CMB Meeting Minutes #174

REFERENCE Project No. M544.1, Contract No. 149 Task 1-8.02

SUBJECT: Configuration Management Board Meeting # 174 – Rev. No. 0

REQUEST FOR INFORMATION**No. 00526****Phone: 415-638-6052**

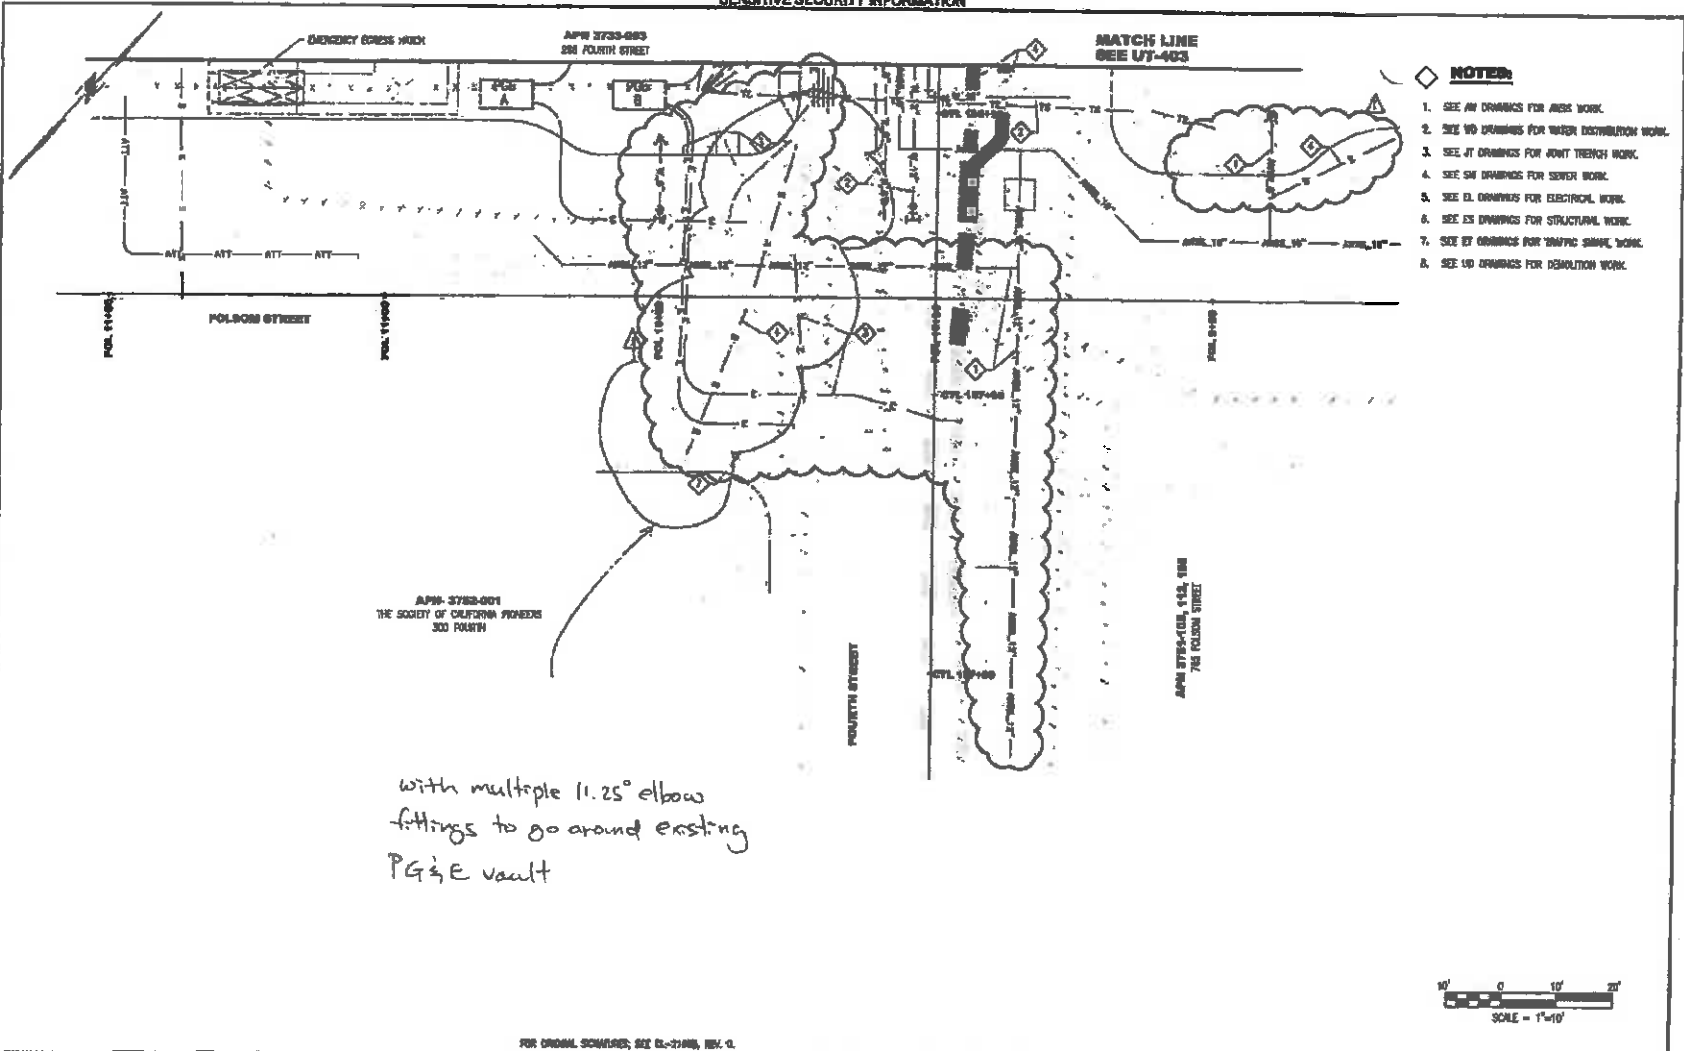
The existing PG&E vault at the N/W corner of Folsom and 4th is in conflict with the proposed 10" VCP culvert. The PG&E vault was found to be 2' +/- to the top of roof and 12' +/- to the bottom of vault. The proposed culvert connects to the existing main at 7' +/- deep.

Please provide direction on how to proceed.

Please see attached drawing. Try to go around the existing PG&E vault with multiple 11.25 degree elbow fittings. If this doesn't work, relocate proposed manhole either westerly or easterly so that you can connect the new culverts.

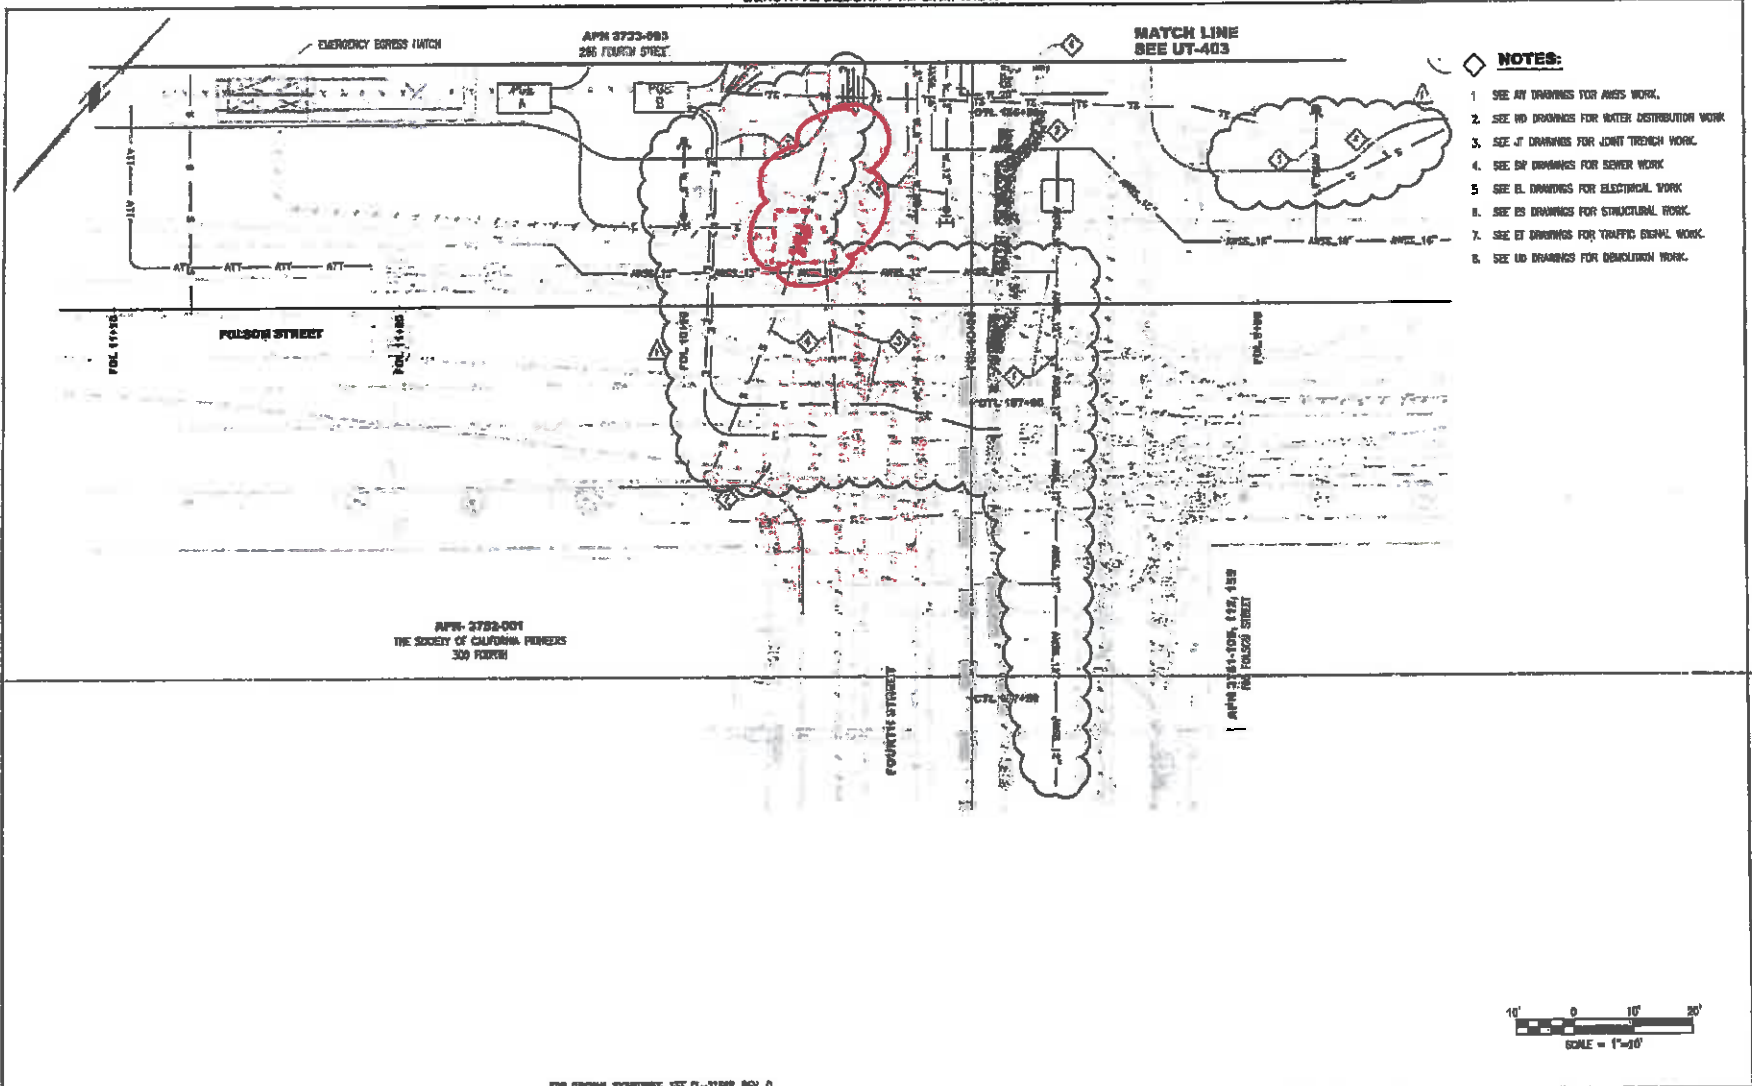
The existing PG&E vault at the N/W corner of Folsom and 4th is in conflict with the proposed 10" VCP culvert. The PG&E vault was found to be 2'+/- to the top of roof and 12'+/- to the bottom of vault. The proposed culvert connects to the existing main at 7'+/- deep.

Please provide direction on how to proceed.

DRAWING NO.	CL-21868														
DRAWING TITLE	UT-413														
SHEET NO.	140														
TOTAL SHEETS	1

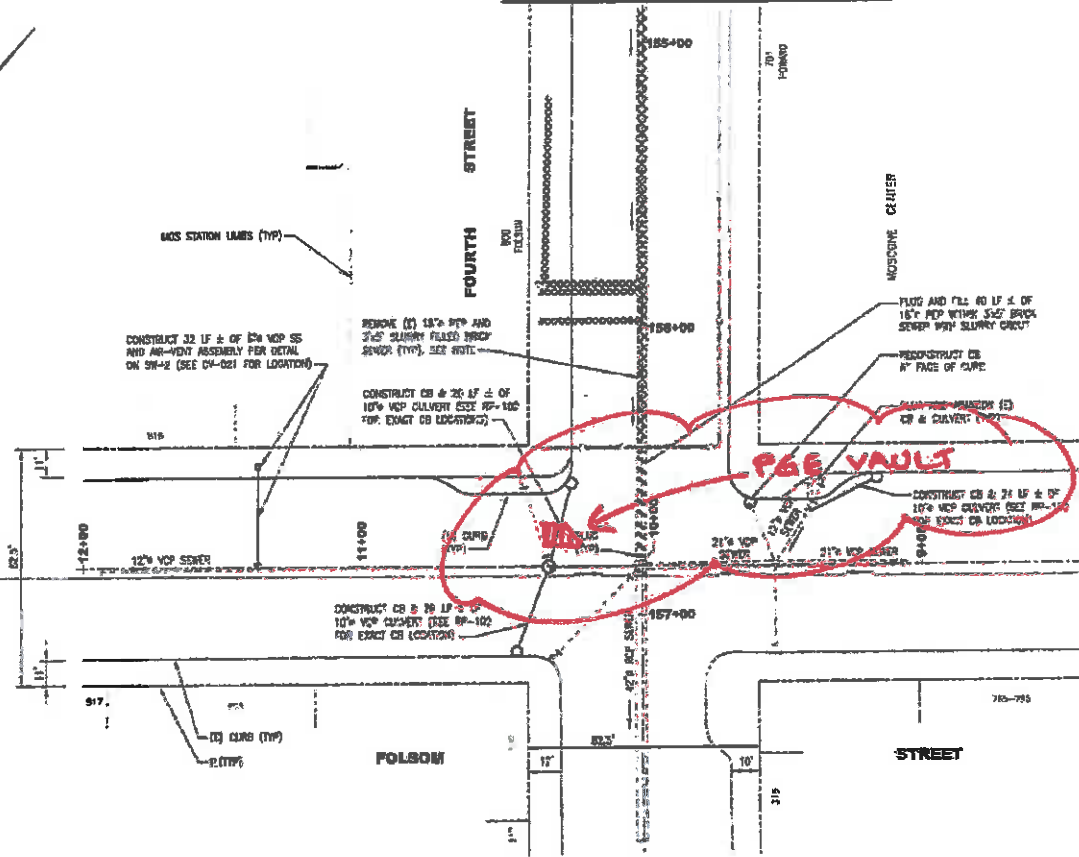
The culvert cannot be installed per plan due to the conflict (alignment and elevation). Per RFI 00526 (attached) the culvert alignment shall be changed to go around the existing vault with multiple fittings and/or relocate the proposed manhole to accommodate the new alignment.

Baseline conditions: The SW drawings do not show the PG&E vault conflict.
